# Stagnant ice and age modelling in the Dome C region, Antarctica

## Review 1 response

Review of "Stagnant ice and age modelling in the Dome C region, Antarctica" by Aildasa Chung et al.

## Review 2 response

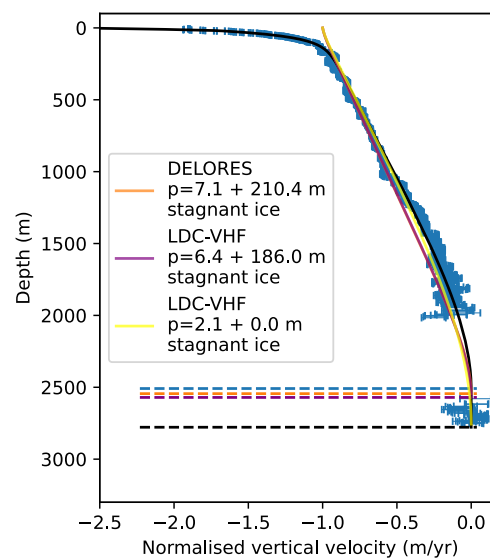
I am writing this as I am reading, so maybe this will pop up further below. Looking at Fig. 11 it seems to me that the fit in Lilien et al. 2021 which does not include  $H_m$  is very good already. Surely the standard

deviation becomes smaller with an additional tuning parameter, but I would argue that this alone is not yet a convincing statement without a physical explanation as to why such a layer would be present.

There is a stagnant ice layer present in Lilien et al.'s modeling work which is now present in Fig 13 (former fig 11) which is close to the LDC-VHF line in our work. We have now added the modelled result assuming no stagnant ice layer- note that we don't include uncertainties as we believe the deviation from the isochrone constraints alone is a clear argument against this model.

Sentence added new line 351:

*For comparison, we show the age-depth profile determined using the model which does not allow for a stagnant ice layer (black line). The profile clearly deviates from the isochrone constraints (blue circles) at depths >2200 m, supporting the conclusion that the inclusion of a stagnant ice layer in the model is the more appropriate at LDC (Sec. 4.3).*

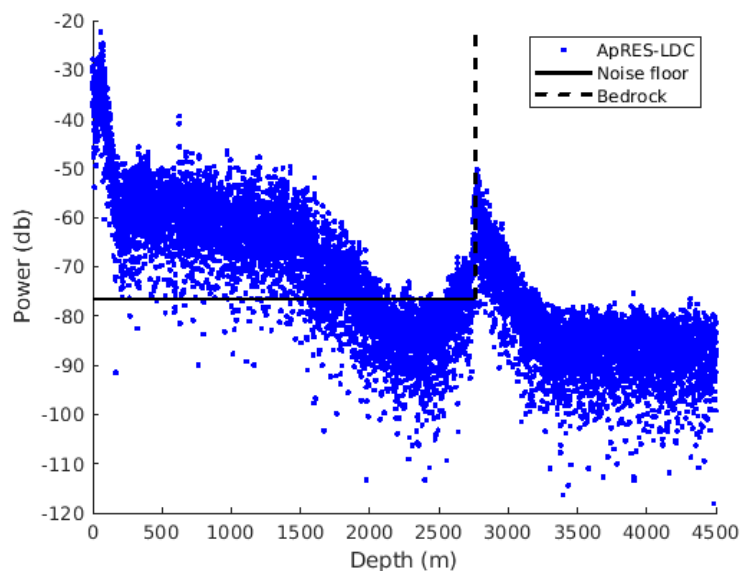
L262 comparing the vertical velocities at LDC and EDC at around 2000m the difference seems to be very small (maybe 0.1-0.2 m/a?). I don't know much about ApRES derived velocity uncertainties, but this seems to be somewhat narrow margins? Again, a more expansive discussion of uncertainties and potential alternative explanations would help a lot here.

**We follow the standard ApRES uncertainty estimation technique described in Brennan et al. (2014) and Nicholls et al. (2015), where phase uncertainty depends on signal-to-noise ratio. Interestingly, the basal unit has a much higher signal-to-noise ratio than ice immediately on top of it. We show here a figure of the return power at ApRES-LDC location to illustrate this point.**

**We agree with the reviewer that we should describe in more detail the ApRES uncertainty and highlight the fact that uncertainty, that inversely relates to signal-to-noise ratio, is lower in the basal unit than in the ice above it. This is unusual as signal-to-noise ratio typically decreases with depth. We are rewriting the document to incorporate these points.**

***We follow the standard ApRES uncertainty estimation technique described in Brennan et al. (2014) and Nicholls et al. (2015), where phase uncertainty depends on signal-to-noise ratio. The uncertainty inversely relates to signal-to-noise ratio and is lower in the basal unit than in the ice above it which is unusual as it typically decreases with depth.***
